## Official Notification - Federal Boat Safety Act Flywheel - 1991 & 1992 150 HP Models

**Models Affected:**

817494A 2

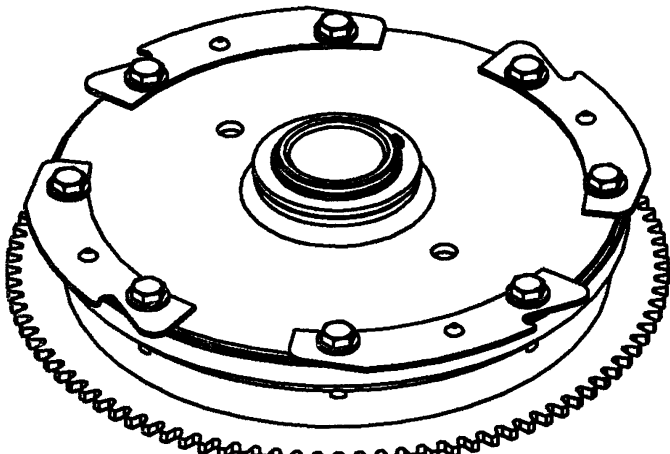
The 817494A 2 flywheel is the solid hub design. This flywheel was being replaced by the 819490A 3 flywheel per Service Bulletin #SB 91-11.

819490A 3

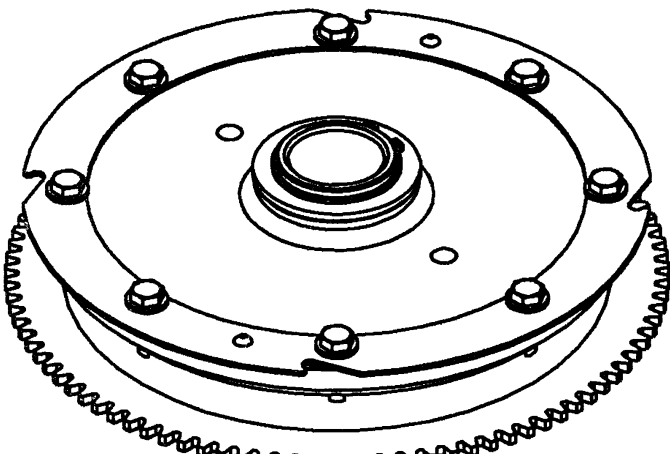
During the assembly process of the 819490A 3 flywheel, some fasteners which retain the emergency starter plates and hub plate to the outer rim of the flywheel were insufficiently torqued. This condition could lead to the fatiguing of these fasteners and ultimate flywheel failure. Such a failure would result in one of the emergency starter plates releasing from the flywheel. The engine cowl will provide protection from possible injury should this occur.

The 819490A 3 flywheel is the original rubber cushioned hub flywheel. This design eliminated an engine harmonic vibration between 4150 and 4400 RPM's, as described in #SB 91-11.

Engineering has re-evaluated the flywheel design. Improvements have been incorporated to make the flywheel easier to assemble and more reliable. The part number for the new flywheel is 819490A 6. This is the replacement flywheel which will be used in this campaign.

The 819490A 6 flywheel is the improved version of the 819490A 3 flywheel. This flywheel has larger fasteners and other changes.
